In the matter of:
Bridger Coal Company
Bridger Underground Mine
I.D. No. 48-01646

Petition for Modification

Docket No. M-2005-037-C

PROPOSED DECISION AND ORDER

BRIDGER UNDERGROUND COAL MINE		
Attachment 'A' Sprinkler System For Freezing And Non Freezing Locations		
No Sods	Date: 3-11-03	REV.

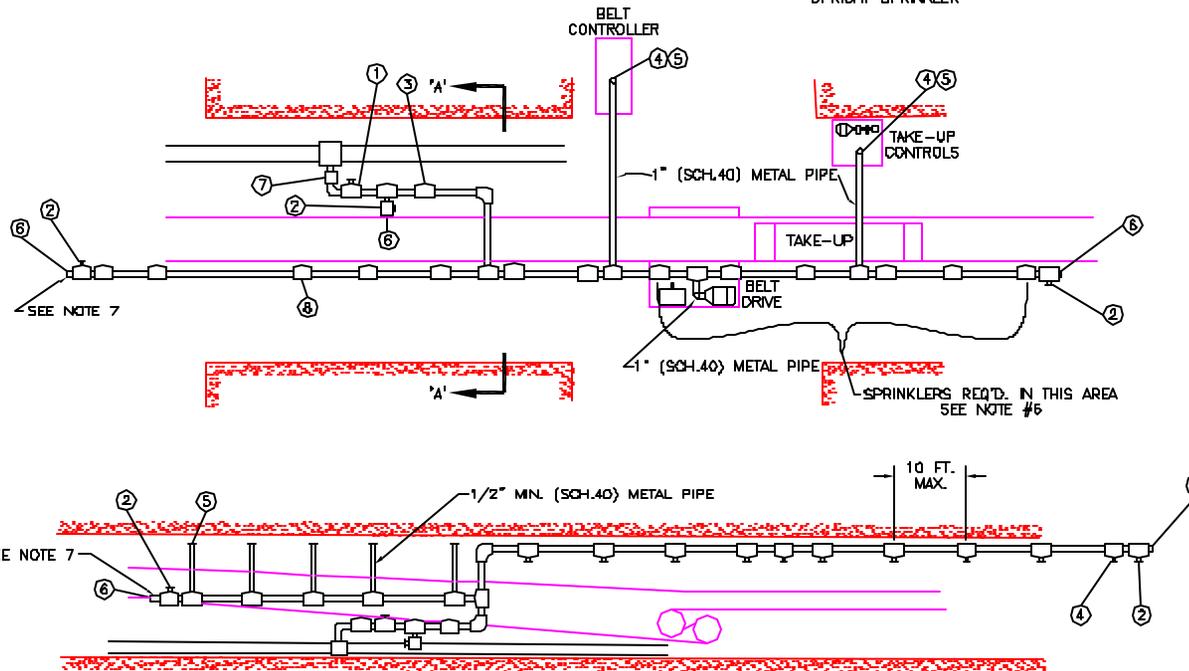
The investigation report included as comments some requirements not included in this PDO. The additional information listed under Item 3, a contingency plan for areas of low clearance, is addressed in the attached drawing (GENU739B). The audible and visual warning device included in the investigator's comments to Item 6 is already required by 30 CFR 75.1101-10, referenced in Item 9 of this PDO.

2. The sprinkler system shall use either pendant or upright type sprinkler heads.
3. Whenever a single overhead pipe is not installed directly over the belt and is installed alongside the belt, it shall be installed in accordance with the petitioner's drawing GENU739B. In both cases, the sprinklers shall be installed above the maximum elevation of the top belt and shall be oriented so that water discharged from the sprinklers will be applied to the entire width of the top belt.
